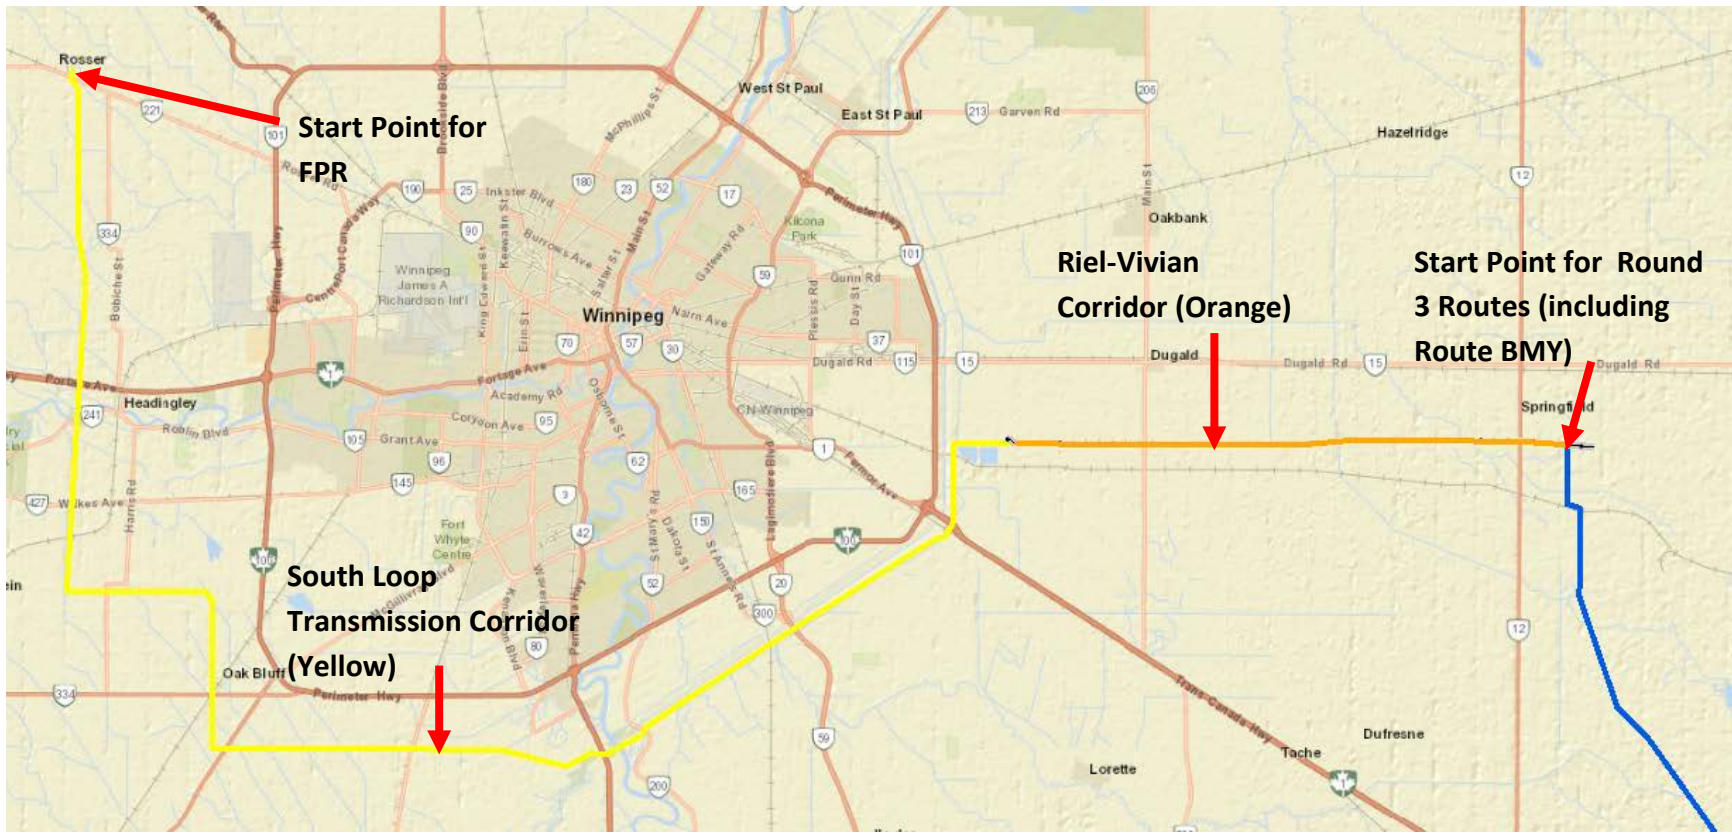
The answer reveals that Route BMY, which becomes the FPR has 17 transmission line crossings, not the 3 crossings indicated in Table 5-33. On the following page (5-117) the Score for System Reliability is shown as a 1. In other tables (see Tables 5-18 and 5-20 as examples) the number of transmission line crossings downgrades the scores (i.e. makes it higher on the 1-2-3 scale). Would the use of 17 crossings change the score compared to the 3 crossings noted in Table 5-33? If not, why not?

- 1 The response indicates that the FPR, not route BMY, has 17 transmission line crossings (from
- 2 Dorsey Station to the Manitoba Border). Route BMY and the FPR have different start points
- 3 (same end point, the Manitoba Border) therefore a different number of transmission line
- 4 crossings.

- 5 Table 5-33 shows the route statistics for the top 5 routes (including Route BMY) from the Round
- 6 3 preference determination step. The route statistics for the Round 3 routes were calculated
- 7 from a start point along the Riel-Vivian Transmission Corridor (RVTC); to the Manitoba-
- 8 Minnesota border (SSC-IR-407_Attachment). They are not calculated on the common portions
- 9 of the routes (portions along the South Loop Transmission Corridor (SLTC) or the RVTC).

- 10 All 5 routes shown in Table 5-33 have 3 transmission line crossings. If route statistics were
- 11 created for all 5 routes starting from Dorsey Station, all 5 routes would still have the same
- 12 number of transmission line crossings (as the routes are identical from Dorsey Station to the
- 13 Round 3 start point), therefore there would be no change in scoring.
